**CORALVILLE LAKE
WATER CONTROL UPDATE REPORT
WITH INTEGRATED ENVIRONMENTAL ASSESSMENT**

**CORALVILLE LAKE
IOWA CITY, IOWA**

APPENDIX D

**CORRESPONDENCE, PUBLIC MEETINGS
AND PUBLIC COMMENTS**

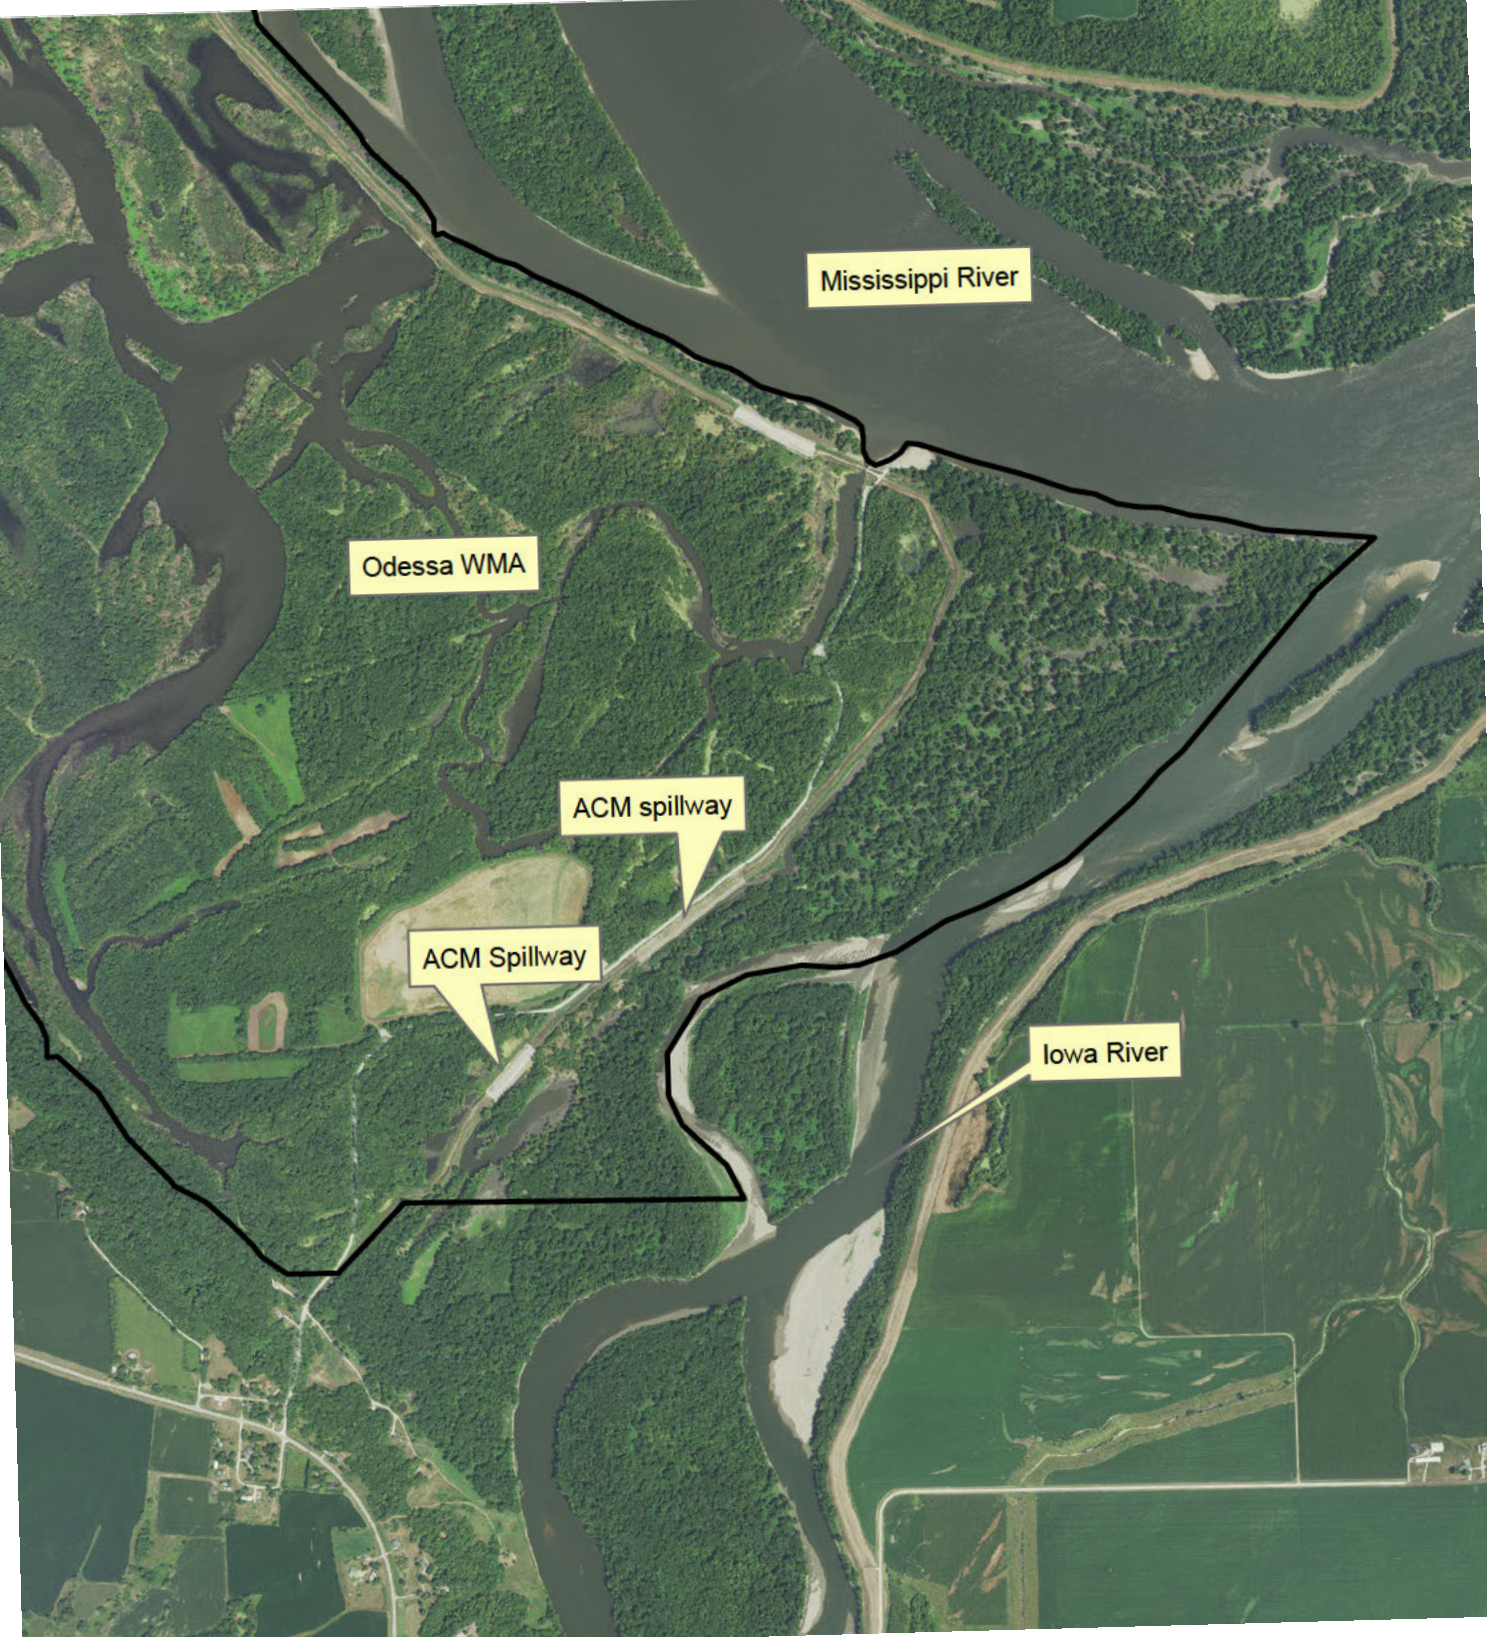
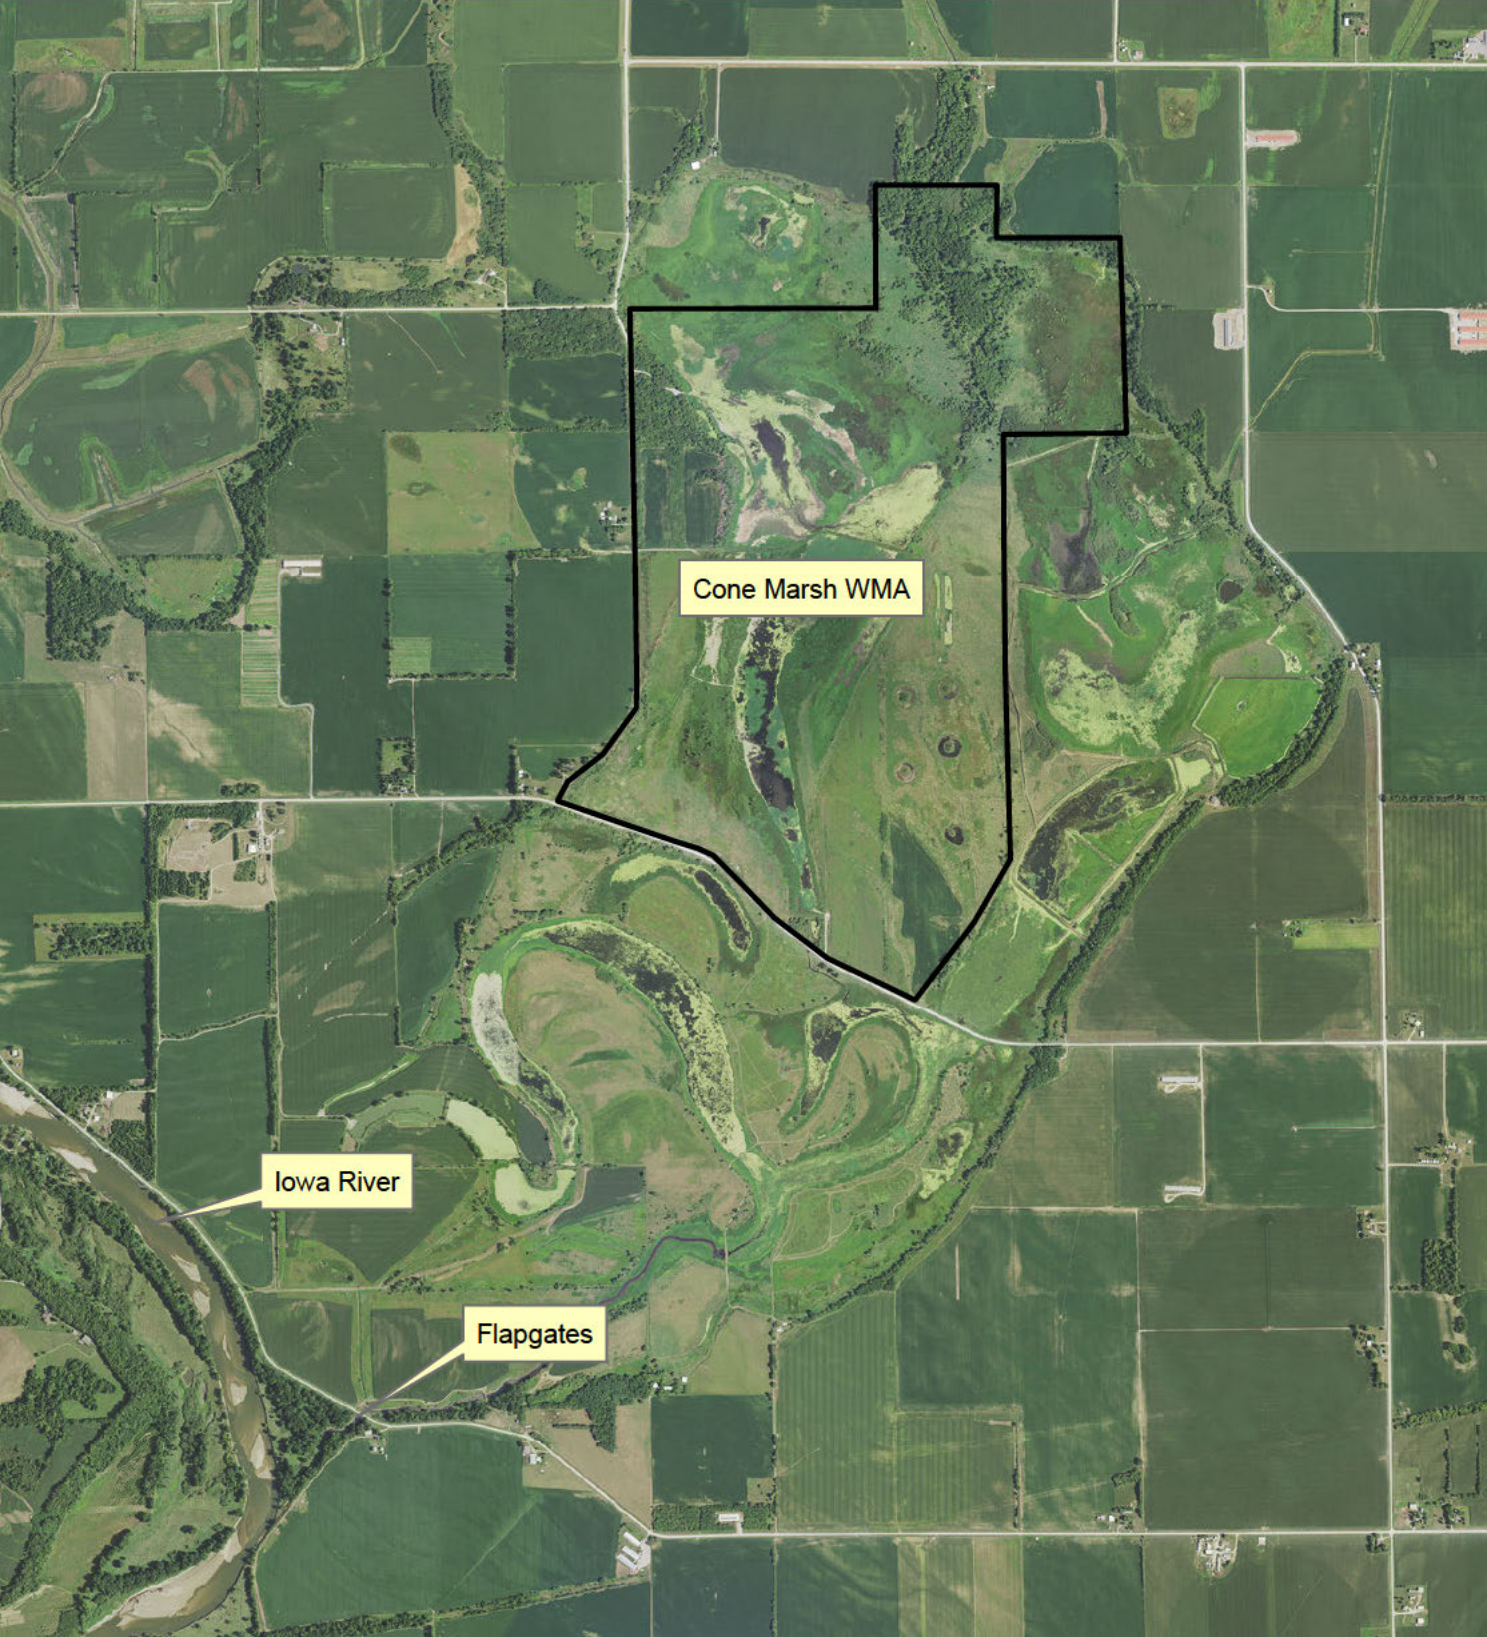
Odessa Wildlife Management Area (WMA) is a 4,107 acre DNR managed area located near the confluence of the Iowa and Mississippi Rivers. It is part of a larger complex that also includes the Port Louisa National Wildlife Refuge comprising an additional 2,609 acres, bringing the complex total to nearly 7,000 acres. This entire area is an extremely important stopover for migratory birds, is home to several threatened and endangered (T&E) species, contains some of the last remaining high quality floodplain forest on this segment of the Mississippi River, and is also heavily used by the public for outdoor recreation. As part of a Habitat Rehabilitation and Enhancement Project (HREP) funded by USACE (completed in 2016), several articulated concrete mat (ACM) spillways were constructed in the Odessa levee to help prevent levee damage during major flood events. Two of these ACM spillways are located on the stretch of the Odessa levee that borders the Iowa River (figure 1). These spillways can be influenced by high water levels on either the Iowa or Mississippi Rivers or a combination of both. Potential changes to the water control plan of the Coralville reservoir have the ability to impact these spillways and in-turn could impact nearly 7,000 acres of extremely important fish and wildlife habitat. Increased outflows or raising the height of control points could lead to an increase of spillway overtopping events and increased flooding of the Odessa complex. Increased flooding will lead to loss of food and cover for migratory birds, increased stress to and loss of floodplain forest, increased siltation of wetlands, and loss of public access (3 boat ramps on Lake Odessa and 2 Mississippi River accesses are closed during spillway overtopping events and generally for extended periods afterwards). Exact overtopping levels of the ACM spillways have been difficult to establish because of their location near the confluence of two rivers and their distance from water level gages. However, overtopping has been documented when levels were simultaneously as low as 17.9' on the Mississippi at New Boston, 24' on the Iowa at Wapello, and 13.8' on the Iowa at Oakville.

Other DNR managed WMA's along the Iowa River include Millrace Flats (1,346 acres) and Wapello Bottoms (2,644 acres) located immediately upstream and downstream of the City of Wapello. Millrace Flats and Wapello Bottoms contain a diverse mix of forest, wetland, and grassland habitats. These areas are located in the Iowa River floodplain and are often prone to flooding. However, the current reservoir control points at Wapello have been very beneficial to the management of these areas. While flooding is a natural occurrence on these areas, the reduced flood impacts brought about by the current reservoir water control plan have allowed for more effective management of these areas and more diverse habitat. Significant flood impacts begin to occur around 21 feet at Millrace Flats and approximately 22.5 feet at Wapello Bottoms. Any potential increases to the height of control points at Wapello would dramatically impact these areas by changing the hydrology with increased flood events, creating a higher water table, etc. These potential changes would negatively impact the quality of habitat in these areas by favoring the growth of undesirable vegetation, increasing silt deposition, limiting equipment access for habitat management purposes, and result in reduced public use of these areas.

Another area of concern is the Cone Marsh complex located approximately 2.5 miles west of Conesville, Iowa. The Cone Marsh complex contains over 1,000 acres of publicly and privately owned high quality wetland habitat that is extremely

important for migratory birds. Cone Marsh is located within a levee district with a flap gate outlet structure that drains directly into the Iowa River (figure 2). High water on the Iowa River will close the flap gates which can back water up throughout the complex if the gates remain closed for an extended period of time. Prolonged high water levels in this wetland complex during the growing season will lead to the loss of food and cover for migratory birds and other wetland wildlife, including T&E species. The exact level at which the Iowa River impacts the flap gates is currently unknown. Additional observations and surveys are necessary to quantify the impacts.
